**HIGHWAYS REBUTTAL BY
RYAN DERBYSHIRE MCIHT**

MYTAX FARM, 4 BOURBLES LANE, POULTON-LE-FYLDE, FY6 0PE

**THE EXTRACTION AND PROCESSING OF SAND AND GRAVEL INCLUDING THE
CONSTRUCTION OF NEW SITE ACCESS ROADS, LANDSCAPING AND SCREENING
BUNDS, MINERALS WASHING PLANT AND OTHER ASSOCIATED INFRASTRUCTURE
WITH RESTORATION TO LEISURE END-USES, AGRICULTURAL LAND AND
BIODIVERSITY ENHANCEMENT, USING IMPORTED INERT FILL.**

PLANNING INSPECTORATE REF: APP/Q2371/W/25/6002168

SCP drawing number SCP/260086/D04 and the identified conflict points along Lancaster Road

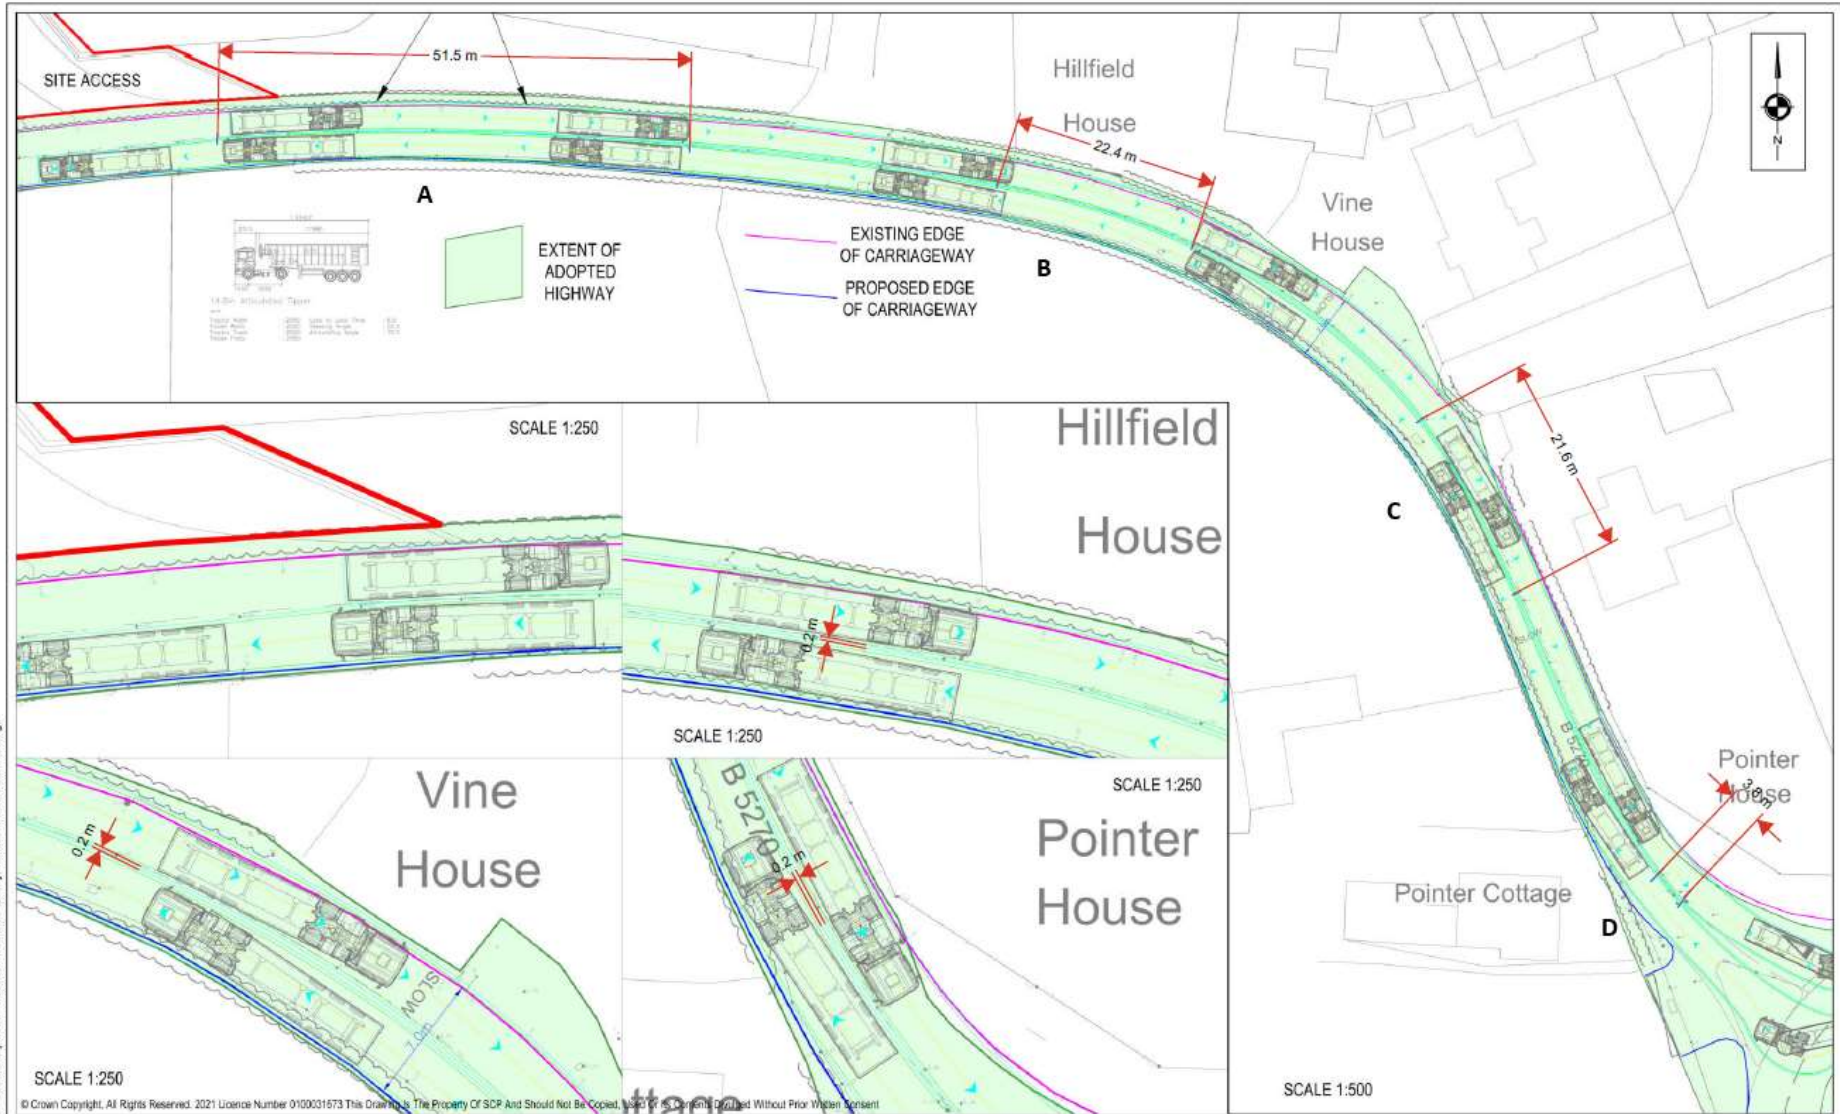
- 2.14. However, part of the SCP proposal which seeks to widen the southern extents of Lancaster Road by 1.4m near the Vine House bend, which would require the removal of approximately 60m of privately owned hedgerow

5.4. However, no details have been provided regarding the extent of the proposed widening to the south of Lancaster Road, except at the Vine House bend, where Mr Budd has proposed to widen the carriageway by circa 1.4m for a distance of approximately 60m by removing the existing private hedgerow which borders the carriageway to the south.

5.6. Regardless of which widening scheme is relied upon, two-way HGV movements along the full length of Lancaster Road still cannot occur without conflict. The new scheme as shown on SCP drawing number SCP/260086/D04 highlights several localised areas (Appendix 1) where opposing HGVs would be unable to pass safely, including on both approaches to the Vine House bend where there will be conflict with HGVs as well as street furniture including the proposed signs and existing street lights, reinforcing the concerns set out in my proof. These unavoidable conflict points present an unacceptable highway safety risk.
